Consideration of PLS testing condition from view point of UN Reg.112 requirement.

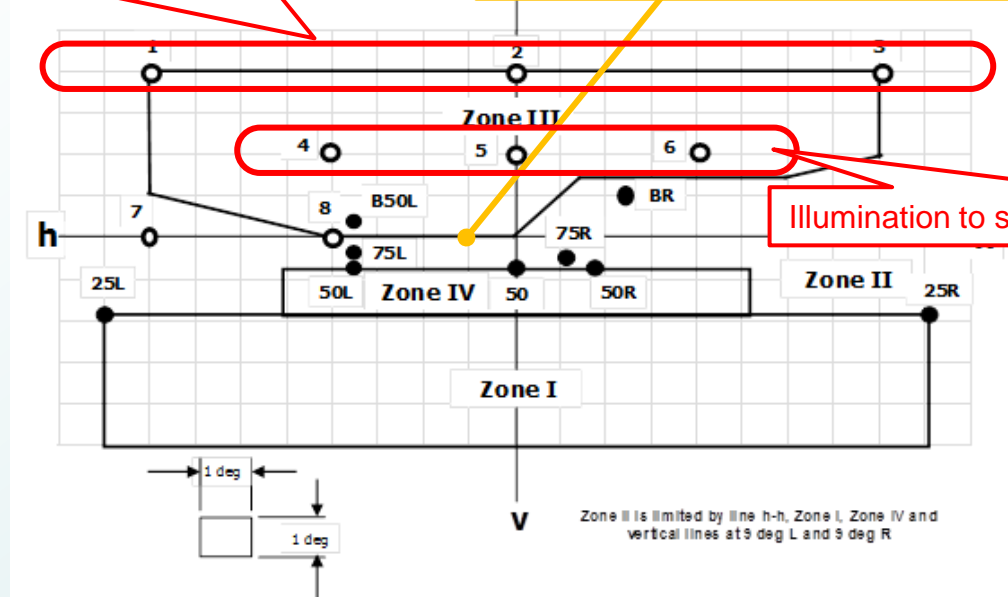
The illumination shall not exceed 625[cd], in any of the orientation measuring point within Zone III.

The sum of illumination measured at points 4, 5 and 6 shall be more than 375(cd). This requirement is to secure that enough illumination to observe the traffic sign standing over the road surface.

The condition 300k to 500k[cd/m²] is too high compared to what is expected from the requirement given in UN Reg.112, restricting the maximum luminance to be under 625 [cd].

Aperture and luminance of LED to emulate a headlamp light at 250 [m] at closer distance than the actual 250 [m] target.

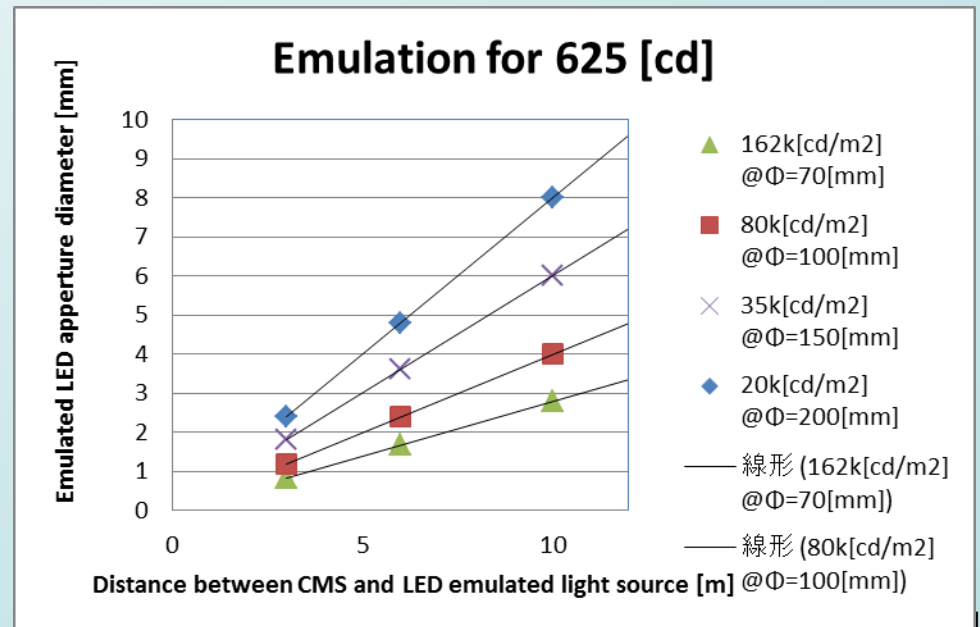
If PLS evaluation is defined to be measured at 6[m], considering a 70[mm] diameter lamp, the aperture of LED shall be defined to be 1.68 [mm] in diameter, luminance set to 162k[cd/m²] and separation between lamp set to 31 [mm]
